LANDSCAPE & LIGHTING PLAN COMPOSITE

PROJECT DESCRIPTION: Prior Approvals

DISCUSSION OF ISSUES

FINDINGS for Site Plan Review:

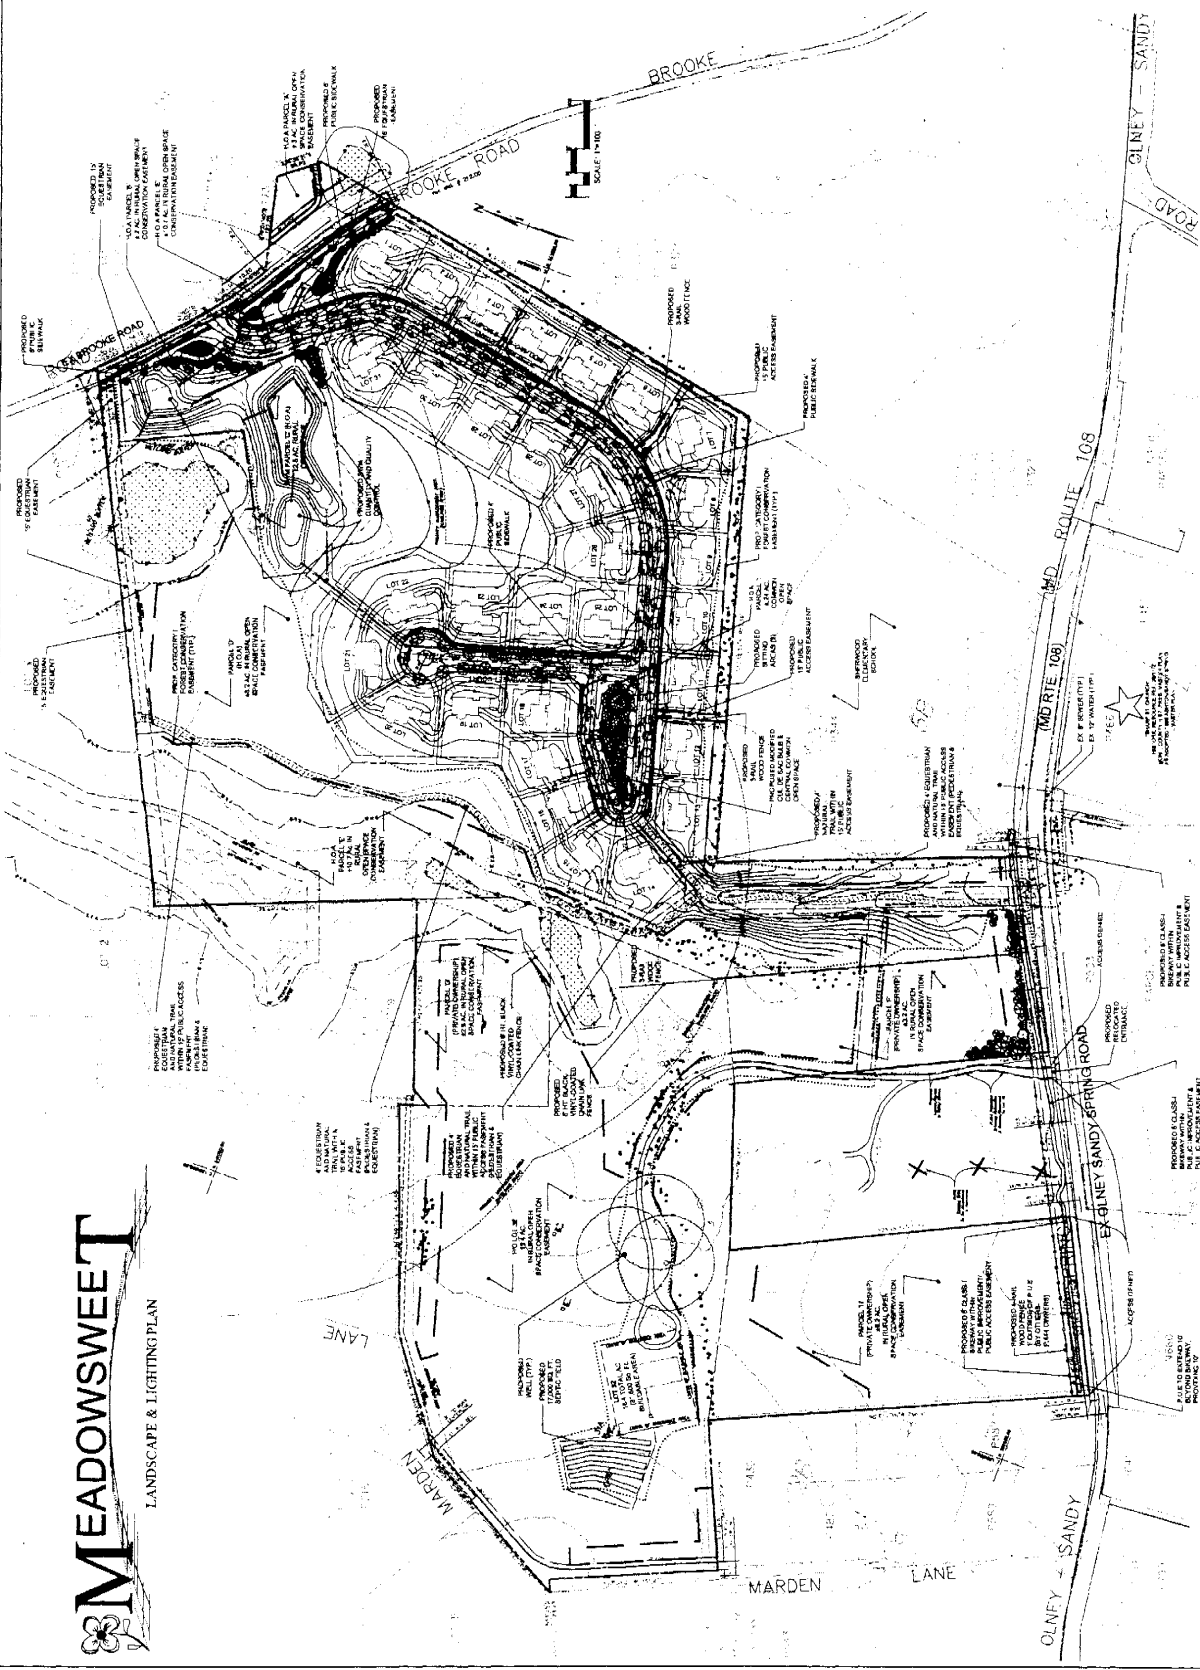
c. Landscaping and Lighting

The landscaping and lighting provides safety and efficiency for residents and visitors in the rural setting.

Landscaping and screening consists of the formal streetscape treatment for the public road and cul-de-sac. Planting is also proposed in the common open space within the islands containing the seating areas and internal pathway. The entrance to the site from Brooke Road provides a formal identity into the property. Buffer plantings have been included along the 5-foot sidewalk and equestrian easement to distinguish the boundaries of the subdivision and trail.

The natural vegetation will form an edge along the Board of Education property. The remainder of the lots backs up to rural open space mitigating the need for additional landscaping.

Proposed street lighting consists of Colonial Post-type fixtures, twelve feet in height creating a rural neighborhood effect. All of the proposed lighting will be located within the proposed rights-of-way for Meadowsweet Drive and Court. The lighting will not cause any negative glare on adjacent residential properties.
